Navigator Quarter, Land adjacent to Southampton Airport

RESPONSE TO ADDITIONAL LLFA COMMENTS

Document No: 30228-BGL-XX-XX-TN-D-00006

Title: Response to Additional LLFA comments

APPENDIX A

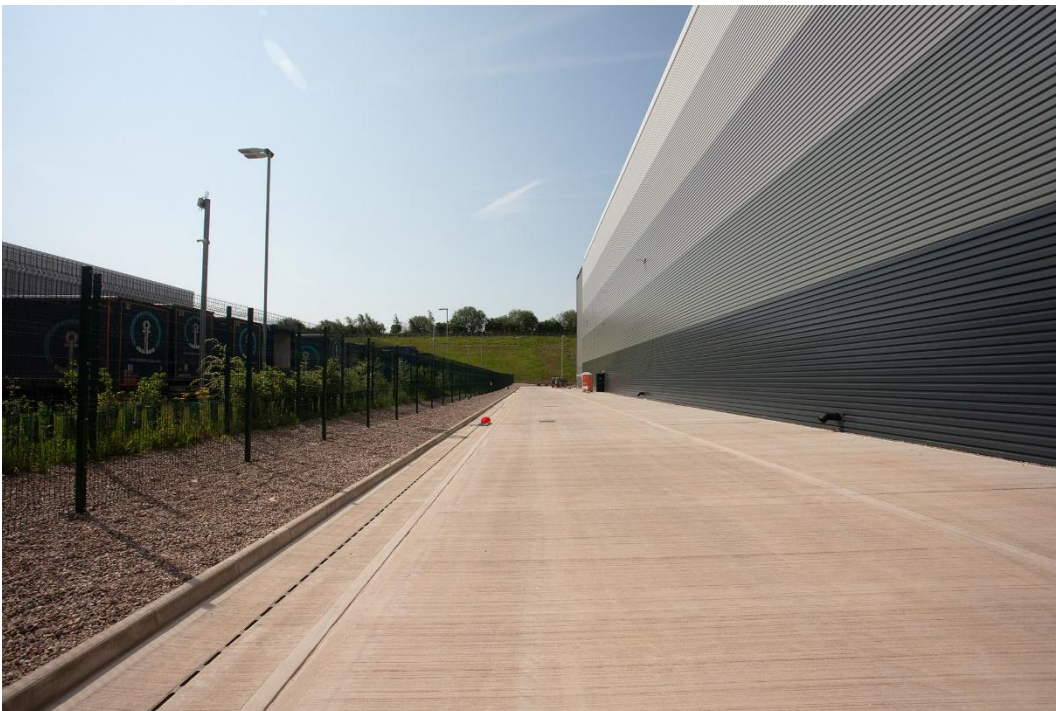
An exceedance flow route plan has not been submitted. We accept that this is a concept / outline stage design, but in consideration of the proposed land level changes, designing for exceedance should be taken into consideration at the earliest stages and prior to determining the application. Conveyance exceedance routes should follow the natural drainage routes through the site. The effect of lowering the land level to the depth proposed has been discussed	<i>As above, we don't have final levels for the plots nor a final layout. This can be provided at detailed design stage to ensure the proposed layout and design takes into account exceedance.</i> <i>Noting concerns from the LLFA regarding the plots being lowered and exceedance in extreme events not being able to flow off plot. This design of a lowered plot is not unusual for industrial warehousing developments of this nature. Most</i>

in depth in our previous responses, in relation to the proposed access road, and the same principles apply to units 8, 9 and 10. We consider there would be a high level of exceedance flood risk associated with the proposed design.	<i>industrial developments have a low lying 1.2m deep dock loading area which will always hold water in exceedance events until it overtops. Similarly, industrial developments of this nature are often designed so that they are lower than all external areas due to other considerations such as landscape/visual and noise mitigation, in this scenario there is no way to allow runoff to off plot areas in an exceedance event. Some examples of this are in Appendix A.</i> <i>It is important to note that the drainage system will be managed by a management company which will mitigate the risk of blockage as far as reasonably possible. The appropriate mitigation for this will be set out at the detailed design stage when the final proposals are known.</i>

The following photographs are examples of sites which are generally artificially lowered to below existing ground levels and therefore there are localised low areas which will hold exceedance flows preventing them running naturally offsite or off yards/pavements.
